# DESIGN CONCEPT: PALM OASIS

# DESIGN CONCEPT: STREAMLINE

# DESIGN CONCEPT: PLAY TIME

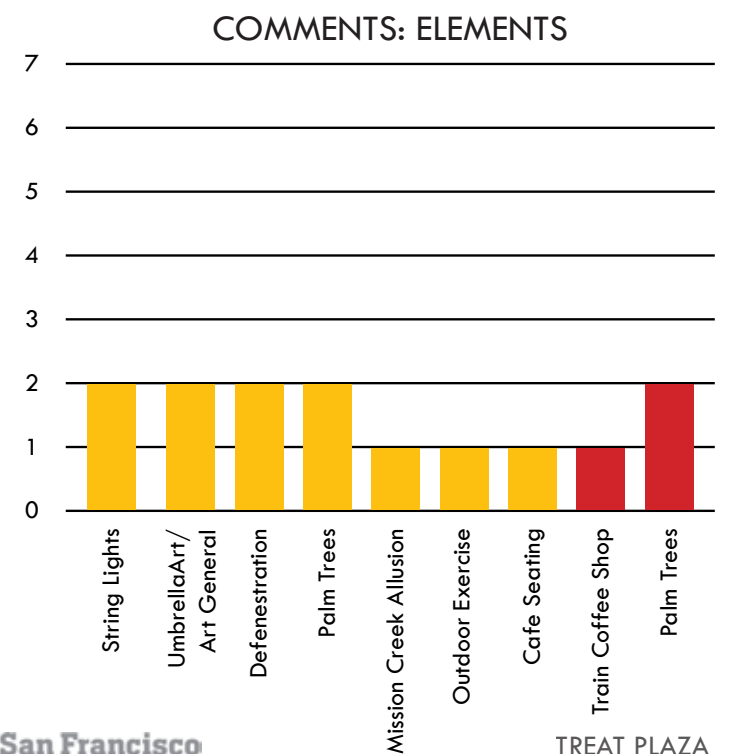
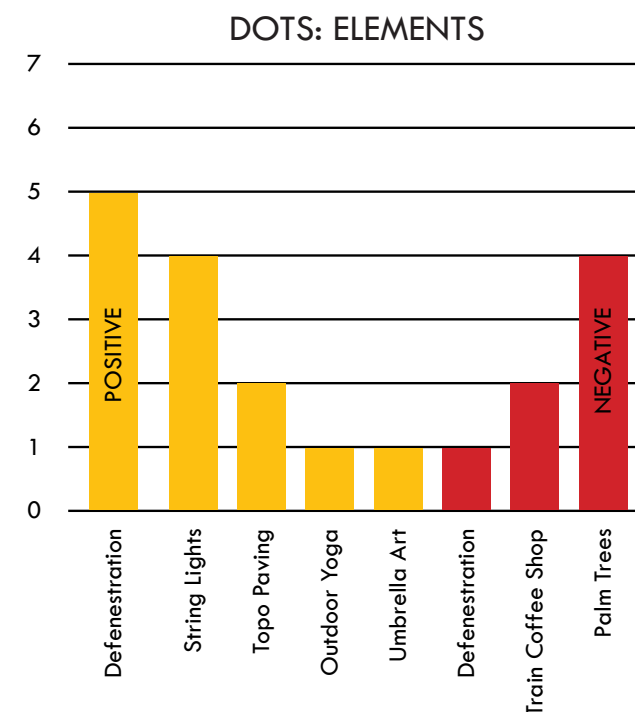
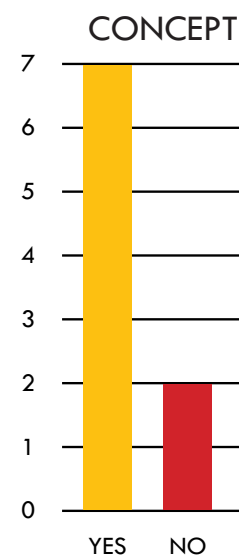
- ① “River → Railroad → Street.”  
“Union Pacific Railway still owns mineral rights under all of this area (it’s on the deeds).”
- ② “Palms add majesty to an open space and have a small footprint for to allow more space for restaurant.”

- ③ “I like the flat plane of the plaza - easy to see everyone!”
- ④ “Not a fan of palm trees.”  
“Not enough vertical barriers for plaza.”
- ⑤ “Palm trees make no sense.”

- ⑥ “Jumping across the street is great.”
- ⑦ “One way with raised crosswalk.” (change traffic to flow Northeast toward Harrison on Treat)
- ⑧ “Like artworks, trees, and seating space.”

- ⑨ “Love the Brian Gogin ‘Defenestration’ sculptures jumping off storage building.”
- ⑩ “With ‘Forest’ needs light for safety.”
- ⑪ “Please add barriers to protect bicyclists from traffic and to prevent Uber/Lyft cars from blocking the bike path.”

- ⑫ “Include the 1860’s bridge. Bridges are great metaphors.”
- ⑬ “Like lights and exercise space.”
- ⑭ “How can we encourage use of space without encouraging camping?”

- ⑮ “Don’t care for train coffee shop.”
- ⑯ “This will get vandalized.” (regarding wall along Dandelion north of staircase)

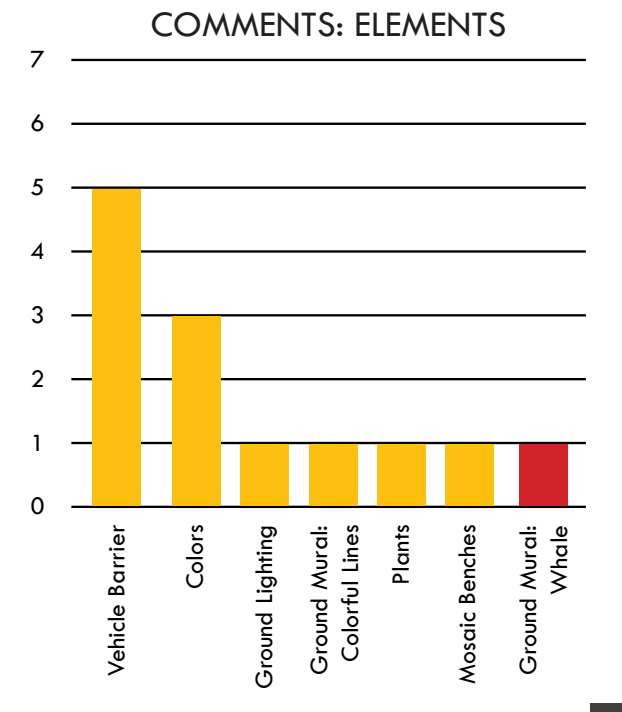
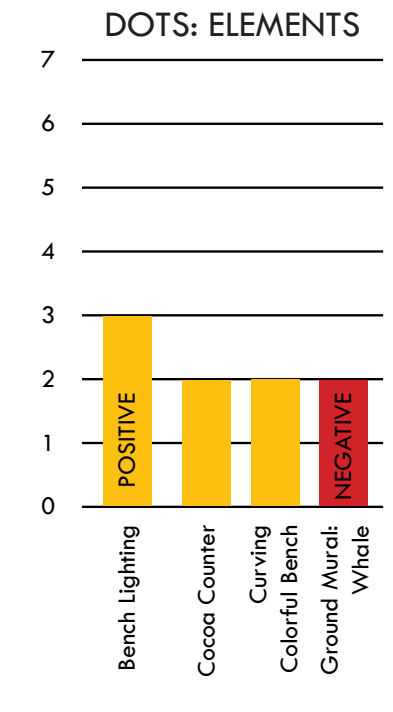
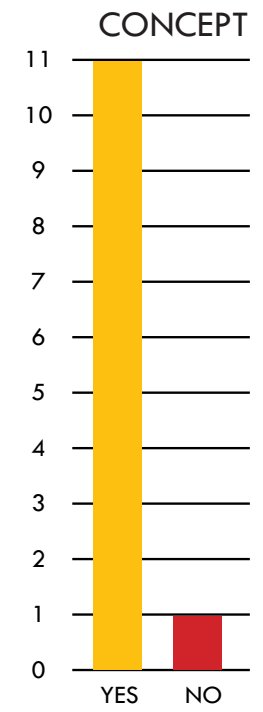
- ① “What does this look like at night? What happens to the tables?”
- ② “Like the vibrant colors and vertical barriers protecting people from traffic.”
- ③ “Put bikes INSIDE the barrier.”
- ④ “ALL OPTIONS should have a concrete barrier protecting people/bikes from cars.”
- ⑤ “Color palette is great, appropriate for the creek.”
- ⑥ “Must not support TENTS.”
- ⑦ “Gaudi mosaic benches similar to Parc Guell.”
- ⑧ “Please highlight the water system under street.”
- ⑨ “Lighting possibly in ground.”
- ⑩ “LOVE the color palatte.”
- ⑪ “Seems too busy.” (referring to whale paving image)
- ⑫ “Please calm the traffic before the cars arrive at this intersection.”
- ⑬ “Please add barriers to protect the bicyclists from traffic and prevent Uber/Lyft cars from blocking the bike lane.”
- ⑭ “Promotes safety from cars.” (pointing at striped pavement mural)
